Access Compliance Report

Public Rights-of-Way

(Curb Ramps)

Intersection ID: 15201	Main Street: ALBEMARLE_RD	Cross Street: LAWYERS_RD	Location: SE
ADA ID: 892E39D0583A	Ramp Type: Perp	Initial Pass/Fail: Fail	Overall Compliance: No
		Severity Score: 8.75	
Codes/Mitigation Info/Possible Solution		Field Measurements/Component Compliance

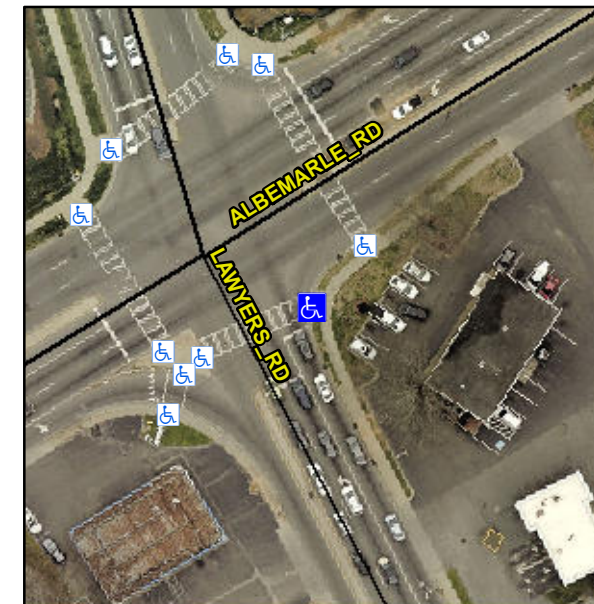
Not Found, R304.5.1

Compliance	Description	Data	Compliance	Description	Data
N/A	Ramp Length (in)	47.5	Yes	Ramp Slope (%)	6.1
No	Ramp Width (in)	47.0	Yes	Ramp XSlope (%)	0.2
N/A	Flare Type LT	N/A	N/A	Flare Type RT	N/A
N/A	Flare Slope LT (%)	N/A	N/A	Flare Slope RT (%)	N/A
N/A	Flare Traversable LT?	N/A	N/A	Flare Traversable RT?	N/A
N/A	Landing Length (in)	N/A	N/A	DWS Provided?	N/A
N/A	Landing Width (in)	N/A	N/A	DWS Contrast?	N/A
N/A	Landing Slope (%)	N/A	N/A	DWS Length (in)	N/A
N/A	Landing X Slope (%)	N/A	N/A	DWS Full Width?	N/A
N/A	Landing Curb? (Y/N)	N/A	N/A	DWS Offset (in)	N/A
N/A	Shared Landing?	N/A			
N/A	Gutter Ponding?	N/A	N/A	Gutter Slope (%)	N/A
N/A	Gutter Lip Ht (in)	N/A	N/A	Gutter X Slope (%)	N/A
N/A	Painted X Walk1?	Yes	N/A	Painted X Walk2?	N/A
	X Walk 1 Direction	To W		X Walk 2 Direction	N/A
N/A	X Walk 1 Width (in)	122.0	N/A	X Walk 2 Width (in)	N/A
	X Walk 1 Slope (%)	1.3		X Walk 2 Slope (%)	N/A
	X Walk 1 X Slope (%)	4.4		X Walk 2 X Slope (%)	N/A

Remove & Replace Entire Ramp.
